SUNDRY NOTICES AND REPORTS ON WELLS

Hill View AHE Federal Com #4

Yates Petroleum Corporation
NM-86241: Hill View AHE Federal Com #4
API: 30-015-26356
Eddy County, New Mexico

RE: Plugging and Abandonment Requirements, Conditions of Approval

WELL NAME Hill View AHE No. 4 FIELD: Dagger Draw

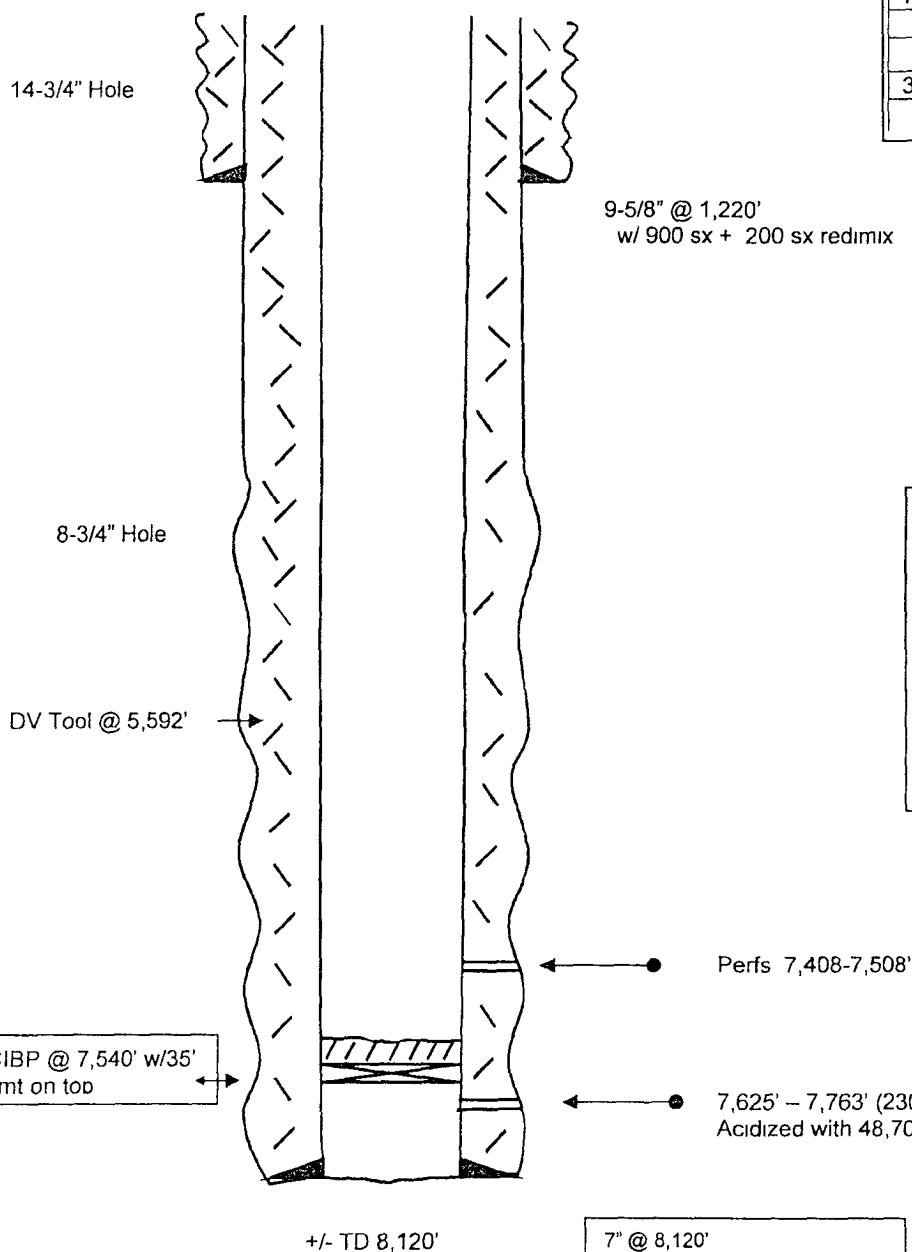
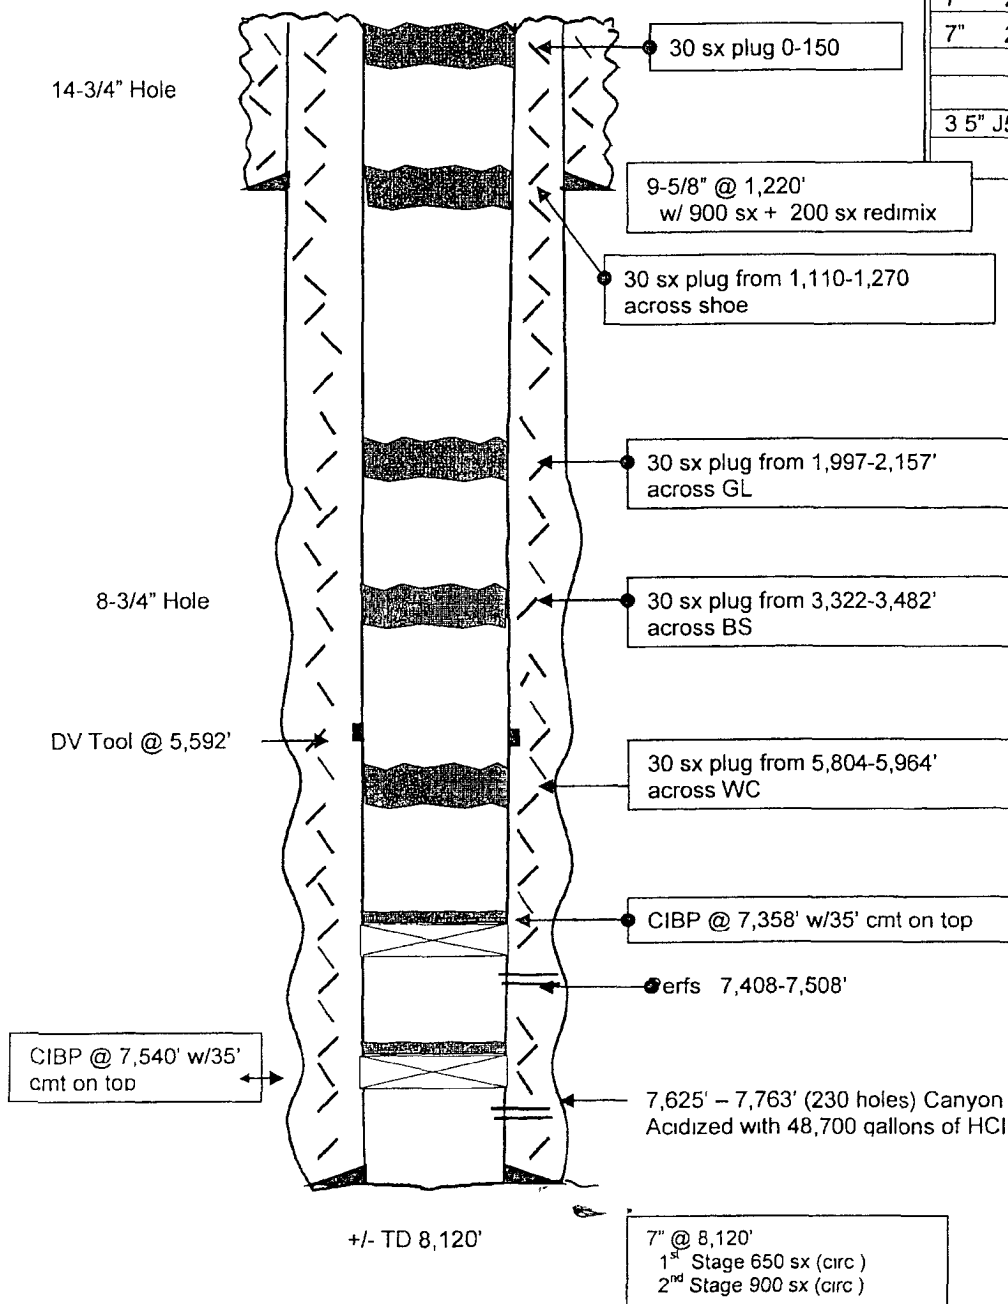
1. MIRU WSU. Rig up any safety equipment as needed. No casing recovery will be attempted. TOH with tubing.
2. Set a CIBP at 7358' with 35' cement on top.
3. Spot a 30 sx Class "C" cement plug from 5408'-5964'. This will put a 160' plug across the Wolfcamp top.
4. Spot a 30 sx Class "C" cement plug from 3322'-3482'. This will put a 160' plug across Bone Spring top.
5. Spot a 30 sx Class "C" cement plug from 1977'-2157'. This will put a 160' plug across Glorieta top.
6. Spot a 30 sx Class "C" cement plug from 1110'-1270' across surface casing shoe. WOC 3 hrs and tag plug. Reset if necessary.
7. Spot a 30 sx Class "C" cement plug from 0'-150' across surface of the casing. WOC and reset if necessary.
8. Remove all surface equipment and weld dry hole marker as per regulations.

H2S monitoring equipment is to be on site. All plugs to be a minimum 25sx.

1. OK
2. OK (Perfs)
3. WOC and tag at 5542' or shallower – Otherwise OK (Wolfcamp – DV Tool)
4. OK (Bone Spring)
5. OK (Glorietta)
6. OK (Casing shoe)
7. Plug to run from 400' to surface – Otherwise OK (Cave/Karst – Surface)
8. Verify Cement to surface in all annuluses – Otherwise OK.
9. Submit a subsequent report to the BLM.
